ARCHITECTURAL SUPPLEMENTAL INSTRUCTIONS No. 1

Re: St Jude Catholic Church

Martsolf Architecture Project No. 2307

1. Sheets revised per City comments.

Drawing Title:
EGRESS/LIFE SAFETY PLAN

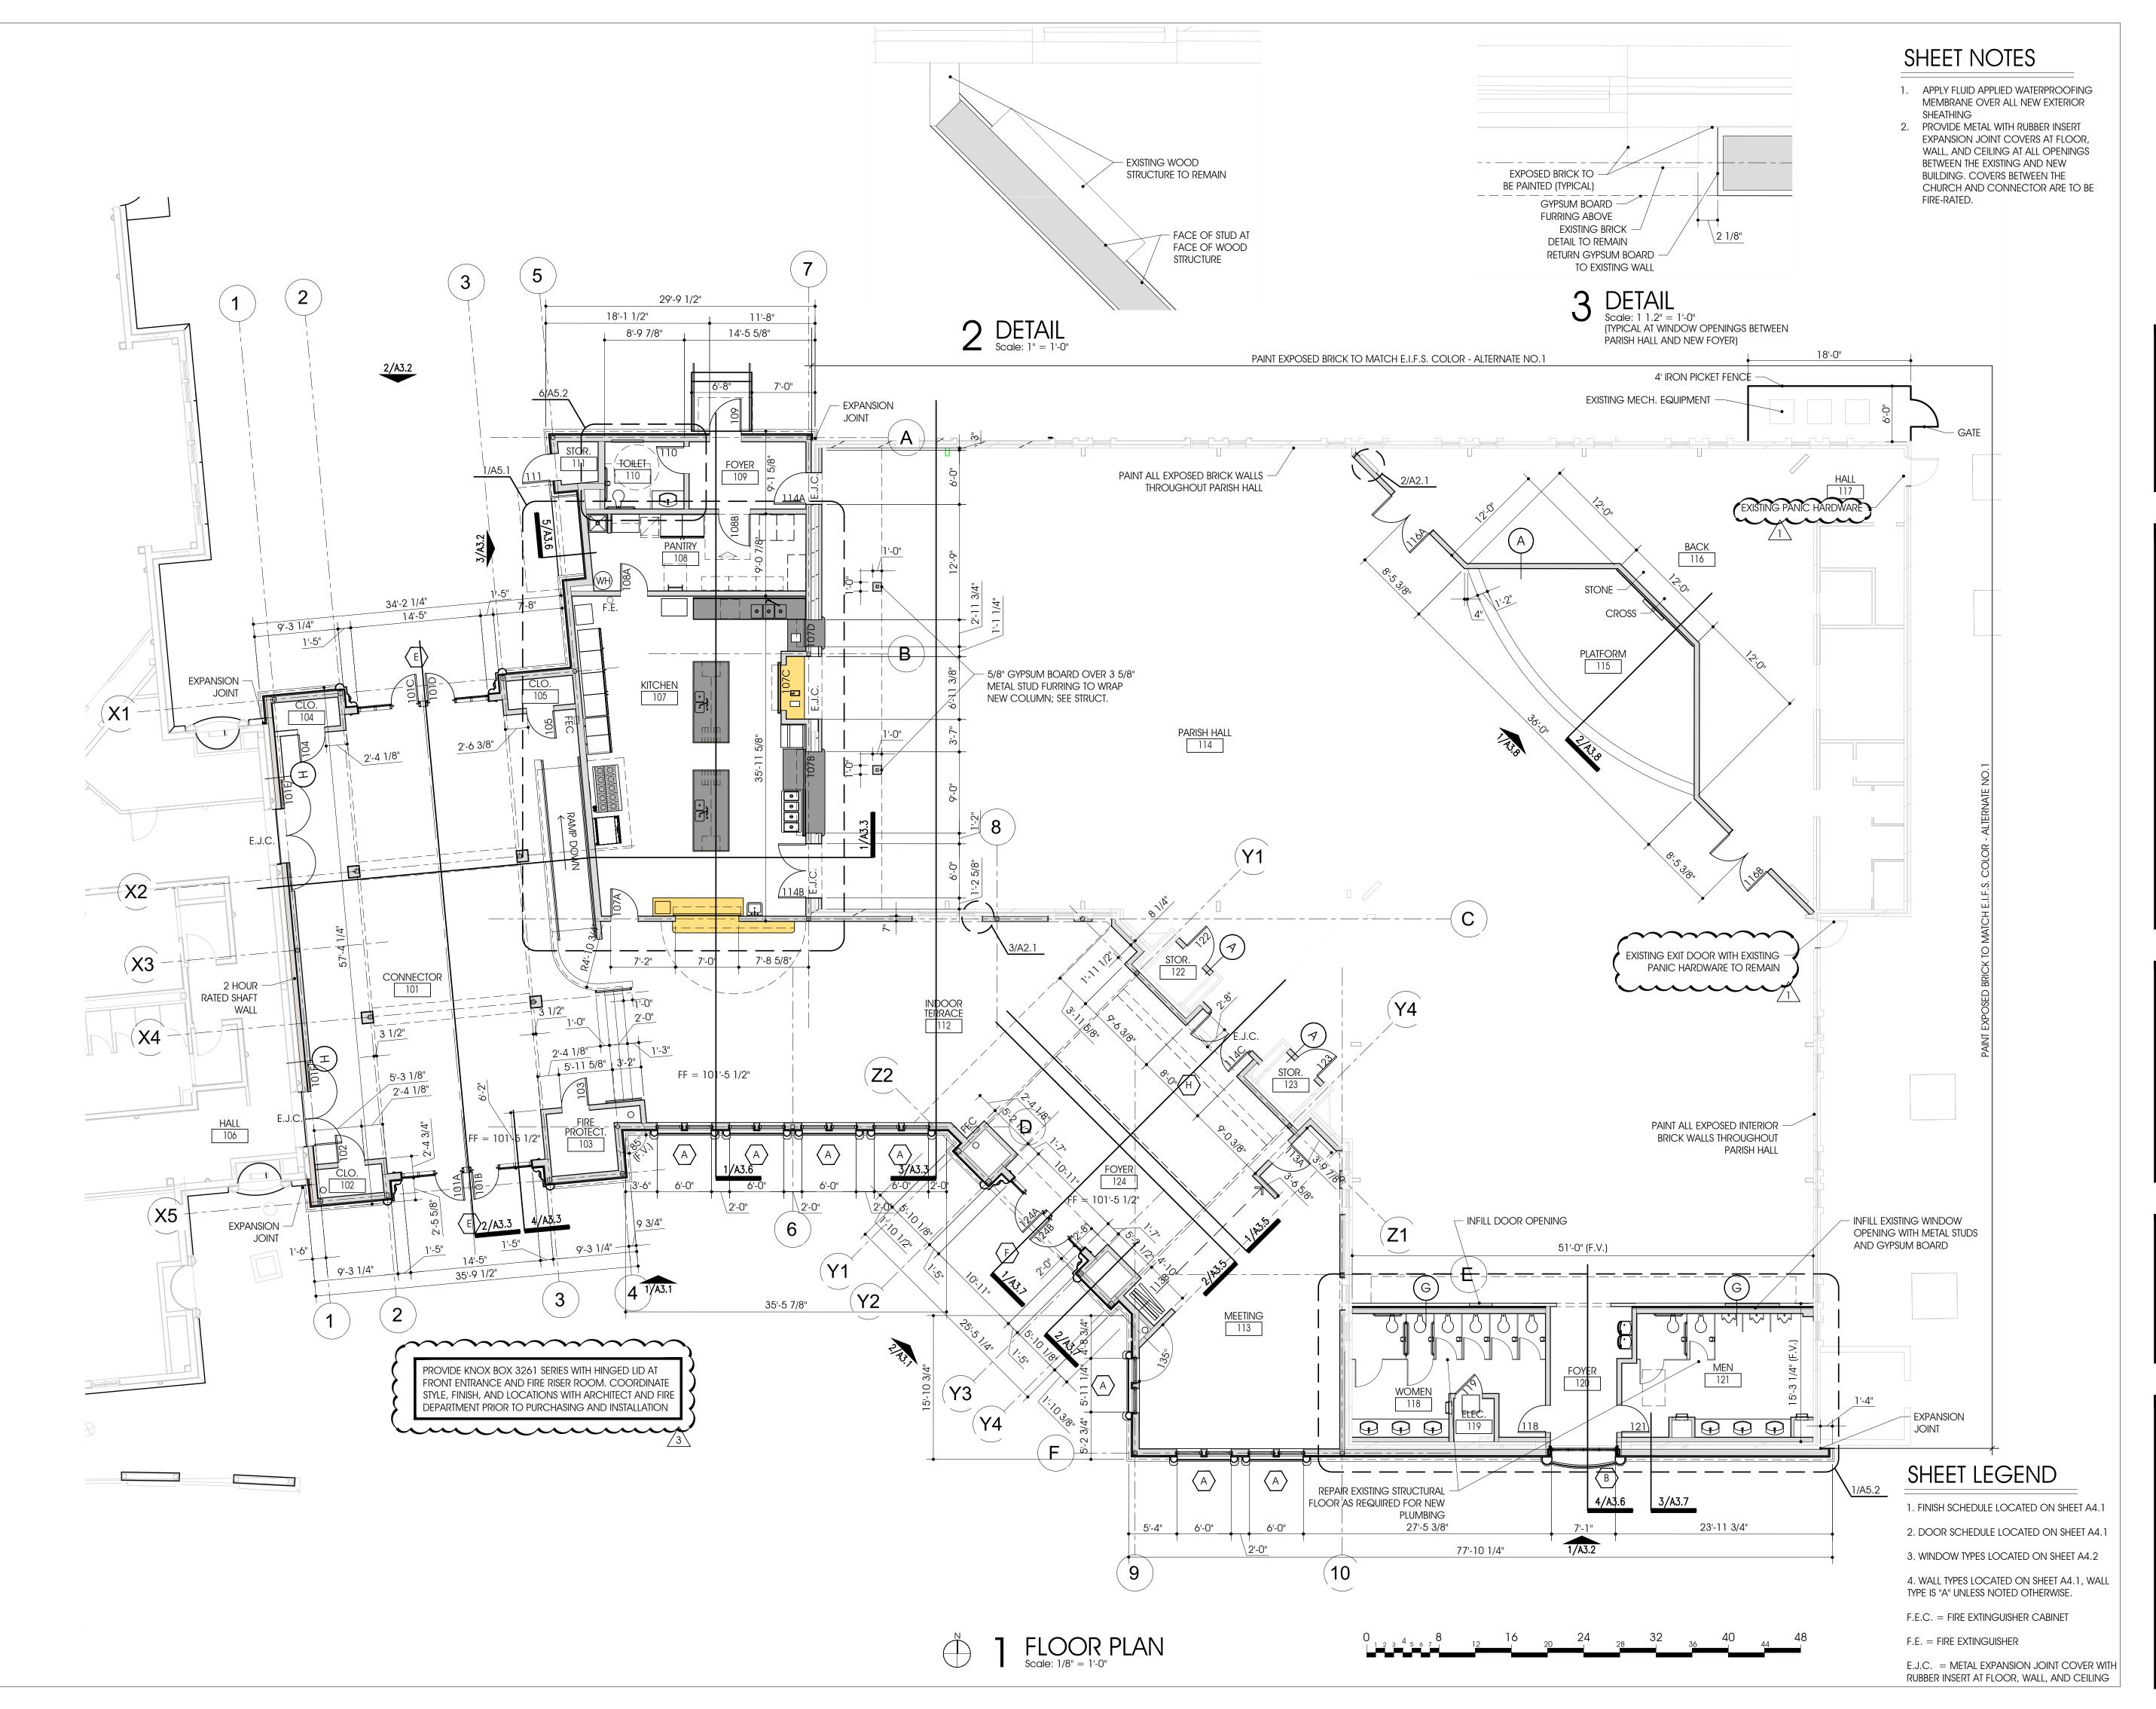
3 3/8/24 CITY COMMENTS

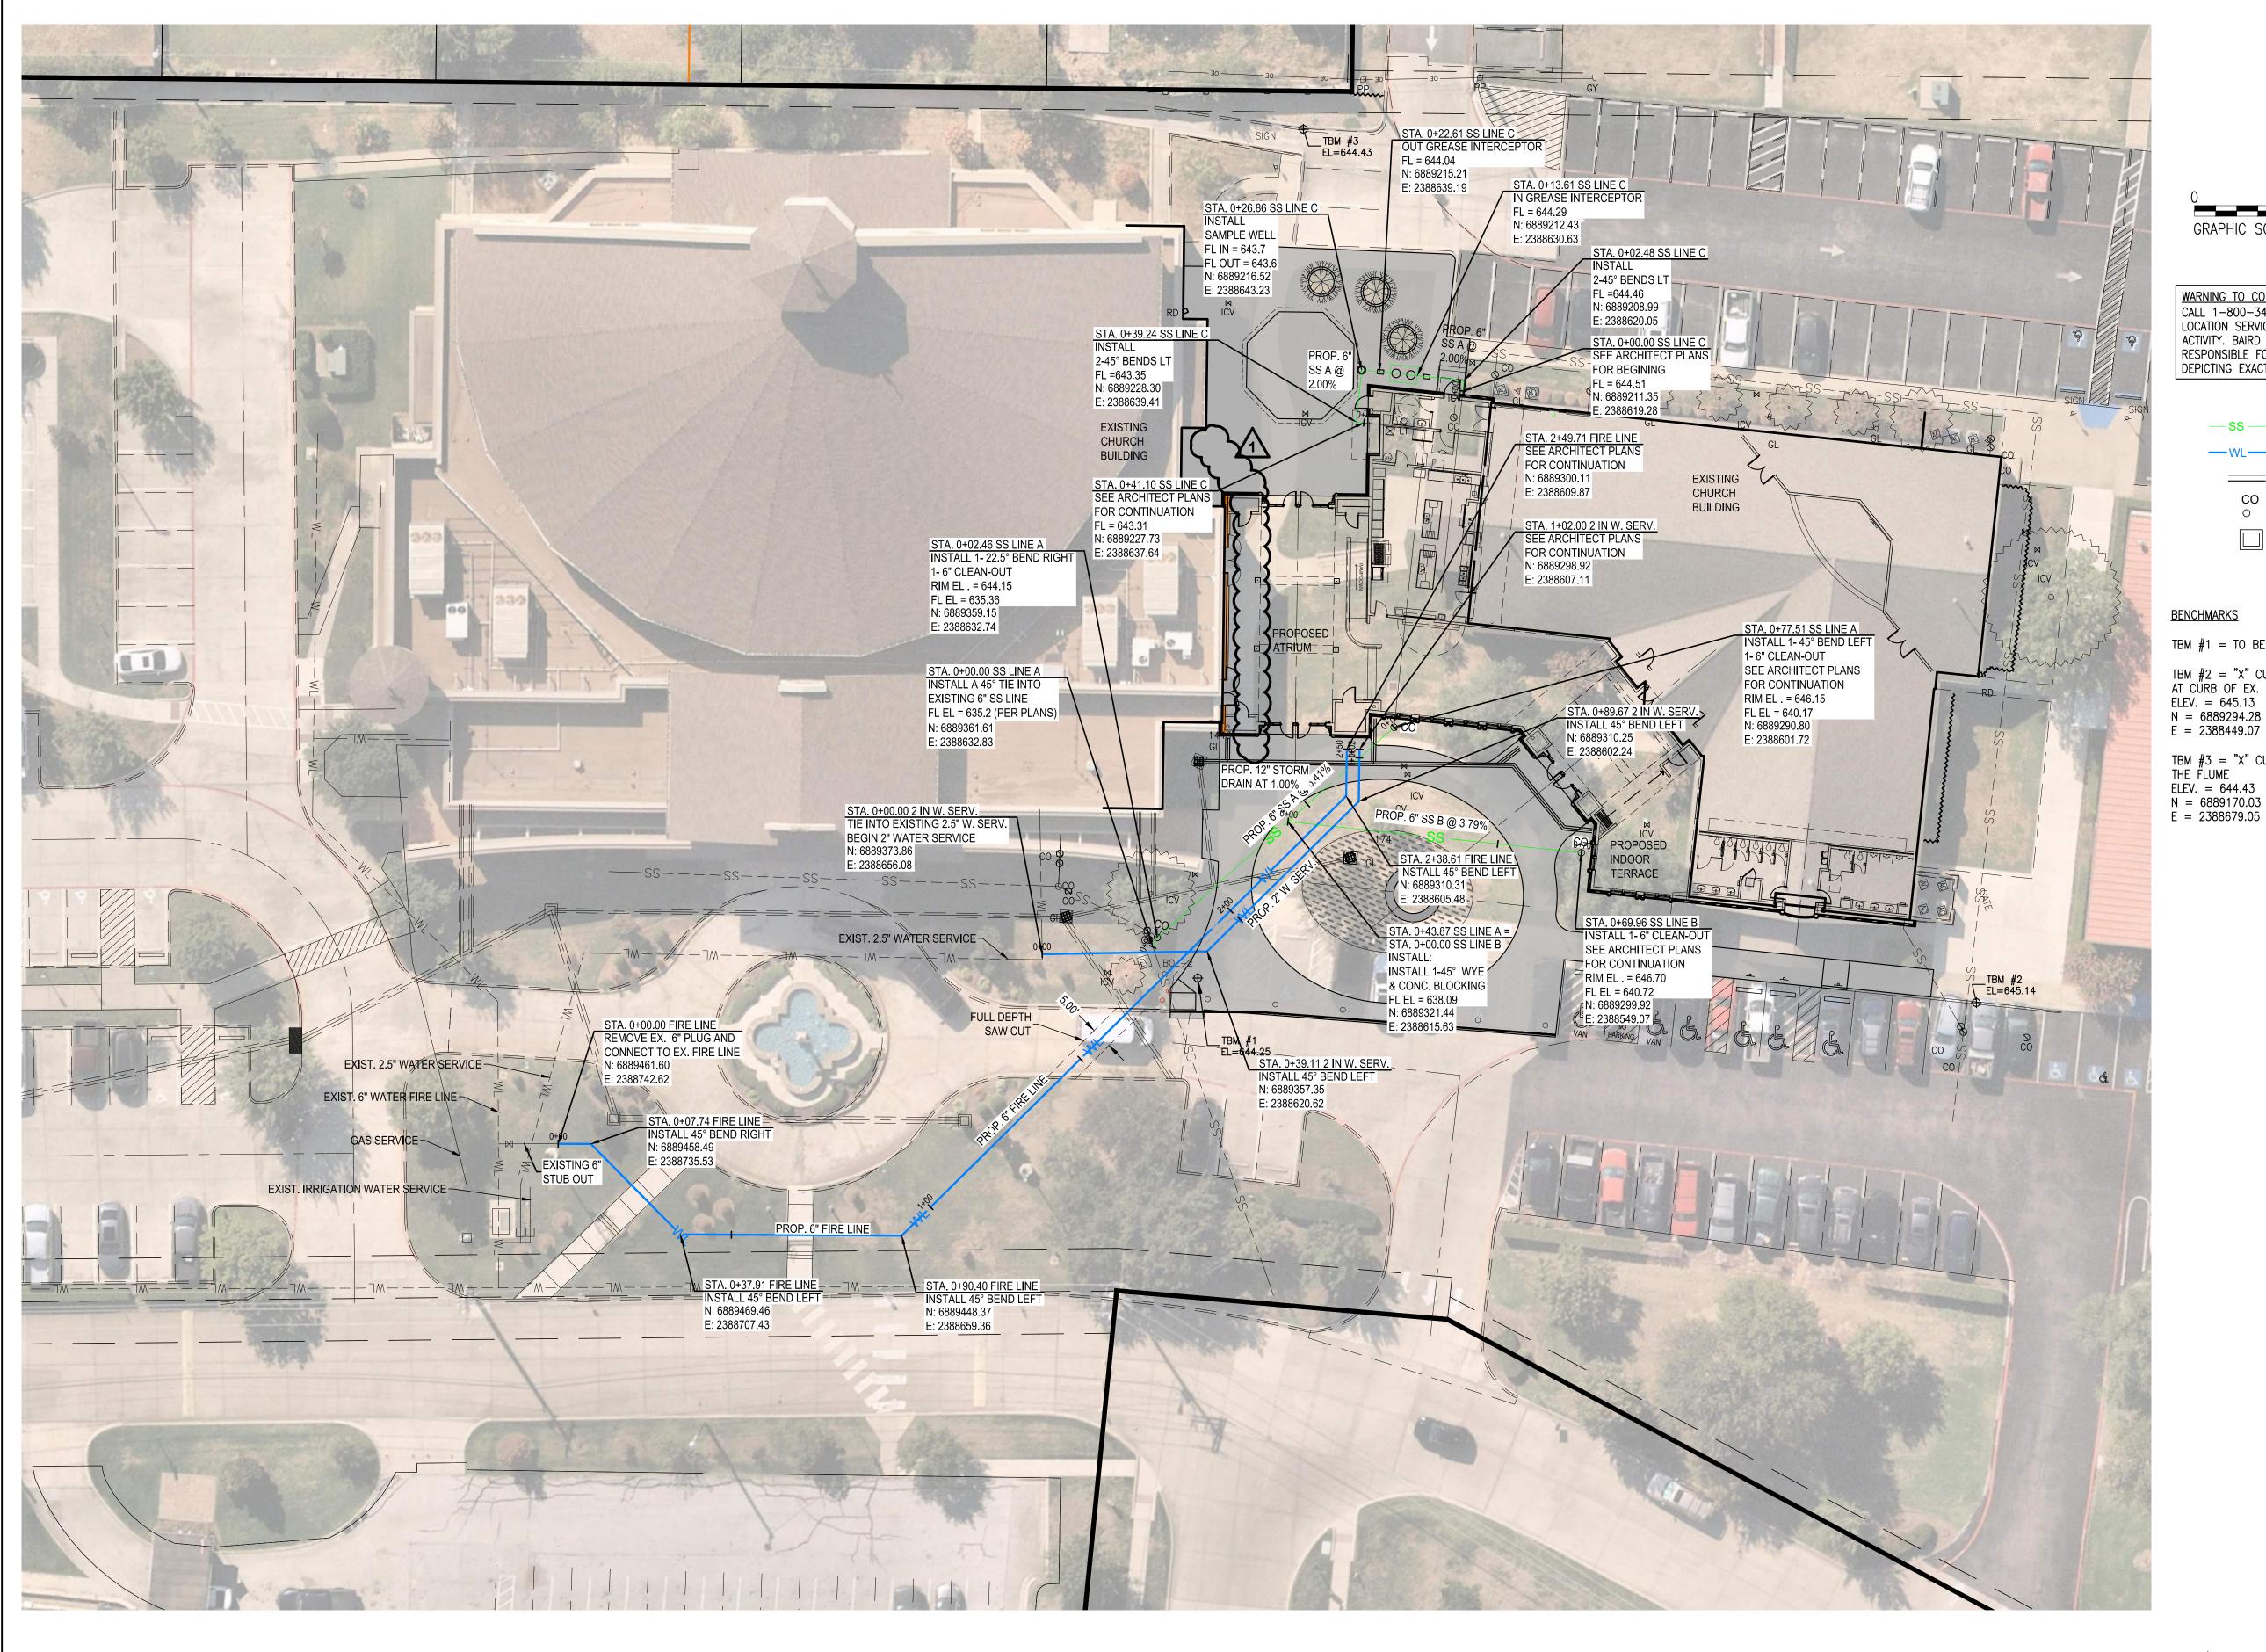
REMOVE STORM DRAIN FROM UNDER BUILDING

Drawing Title: UTILITY PLAN Project No. Date: 1/12/2024 2307 Sheet No.

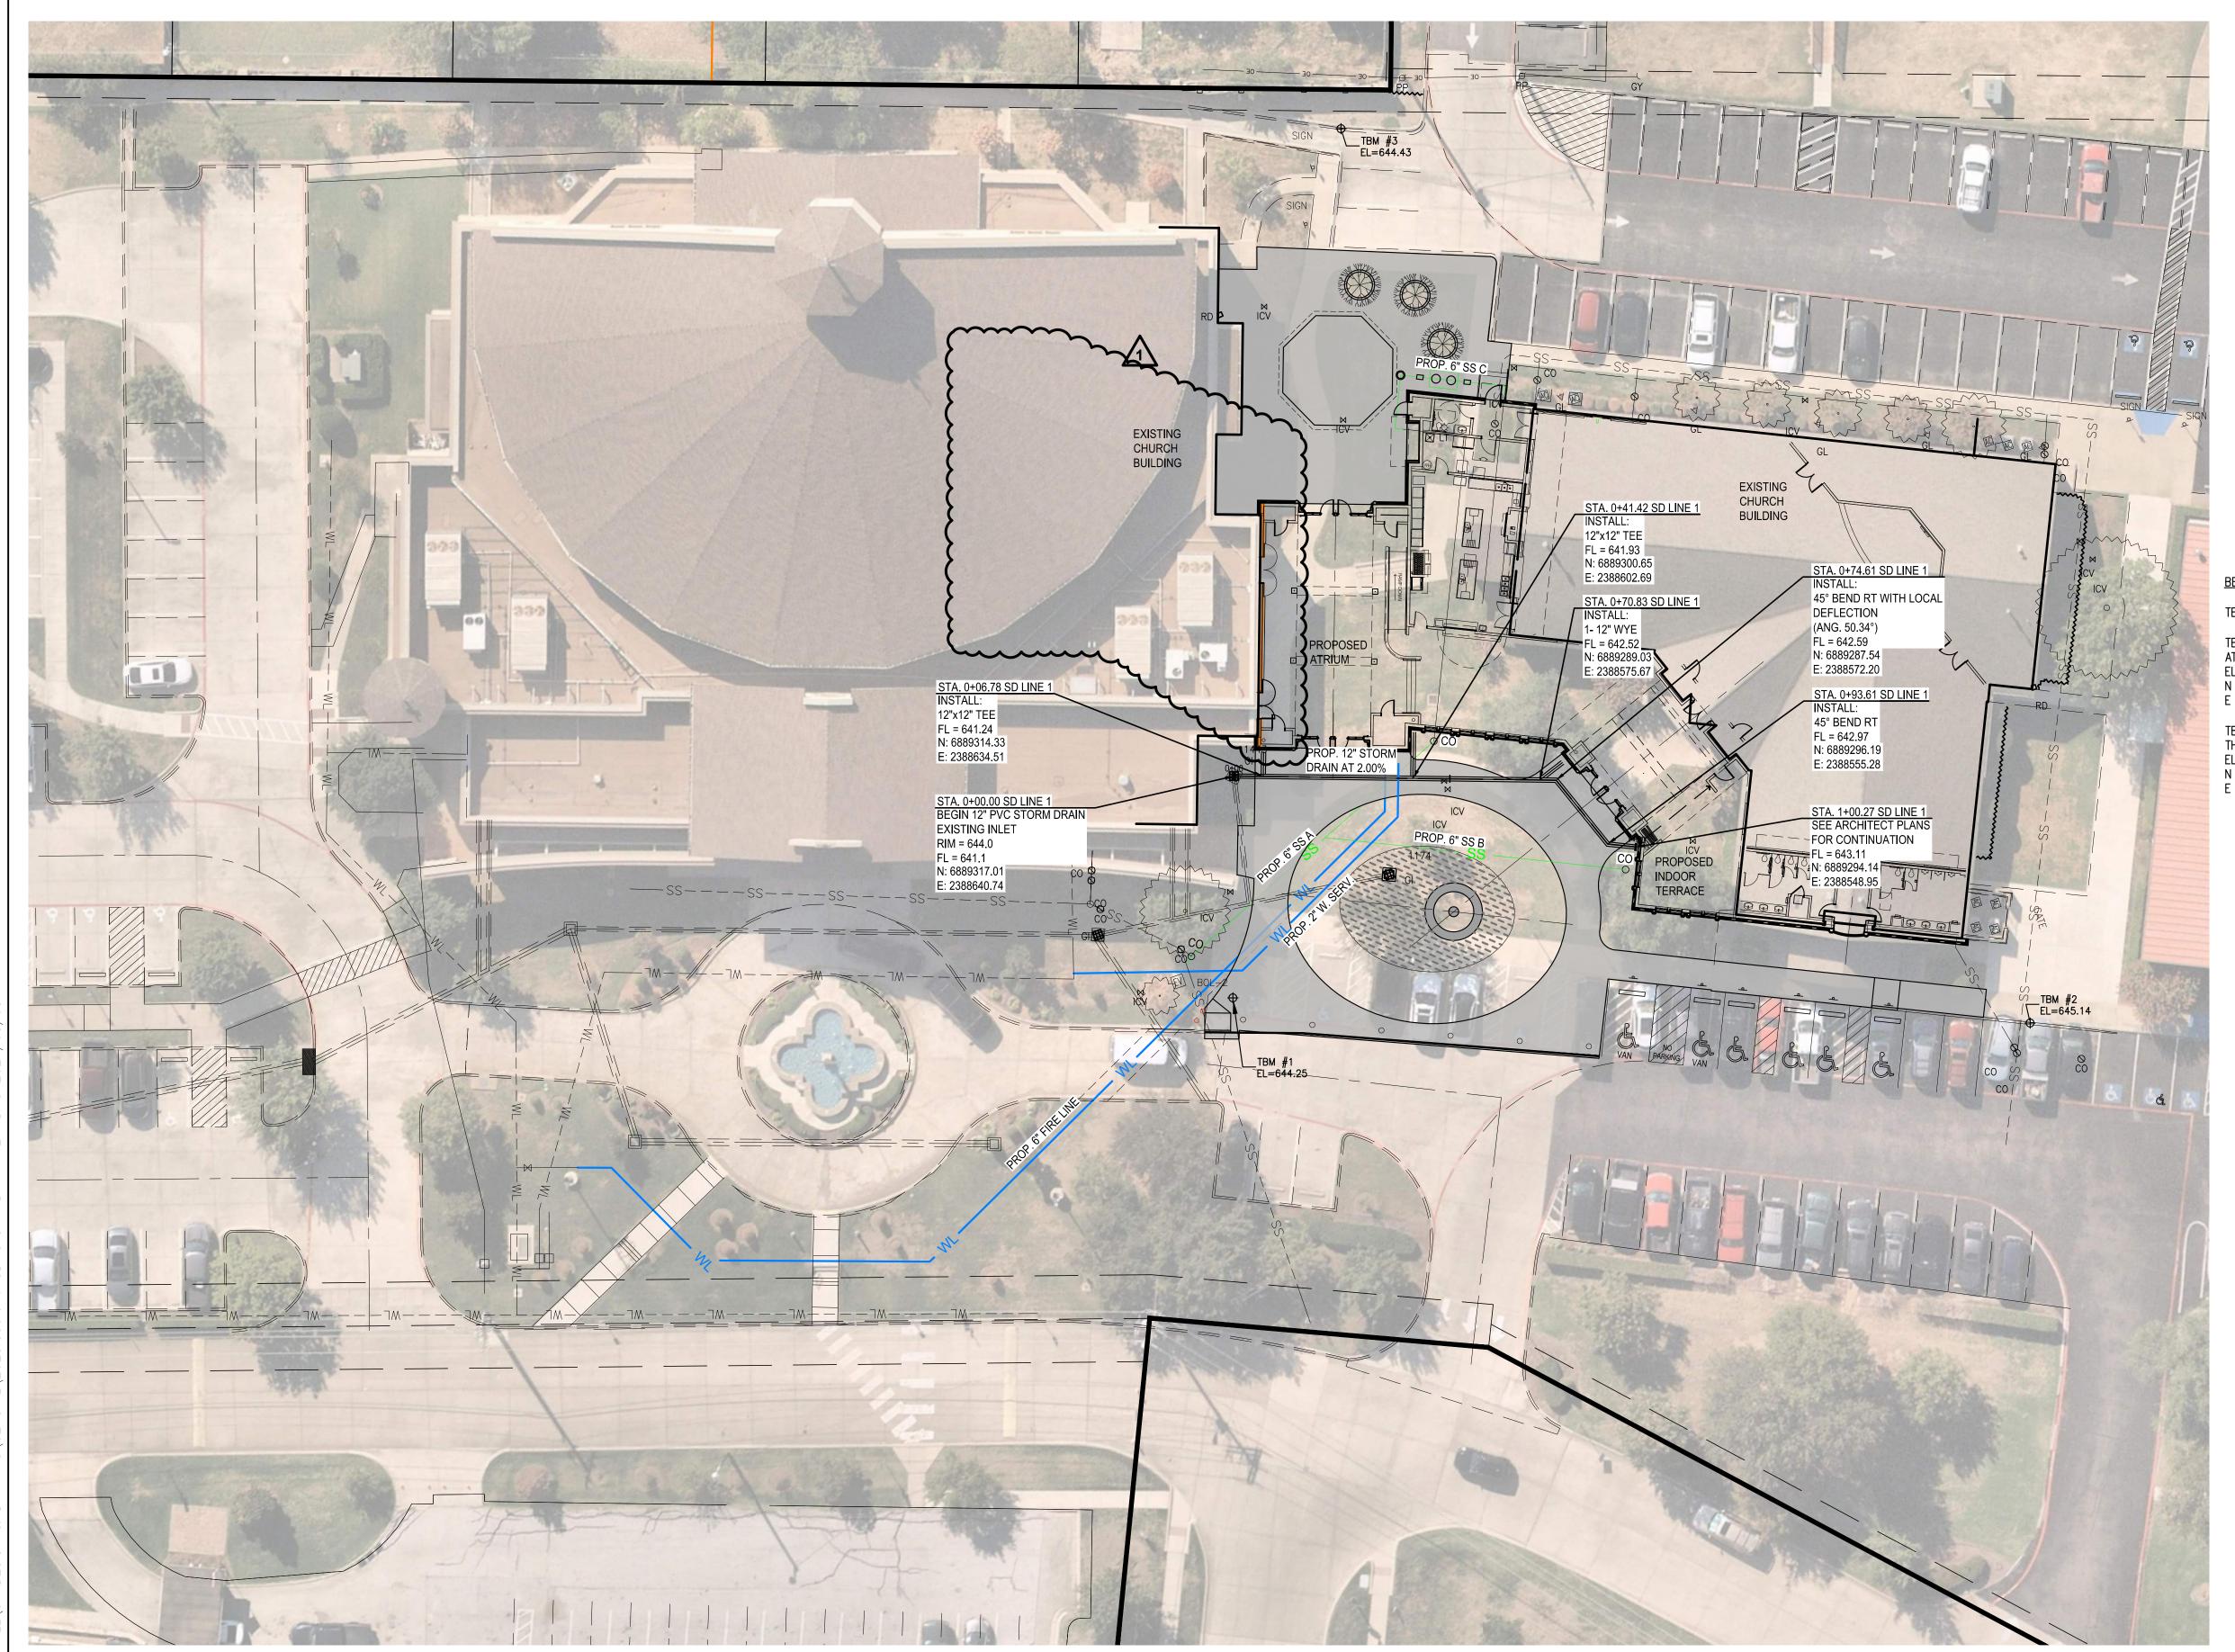
REMOVE STORM DRAIN FROM UNDER BUILDING
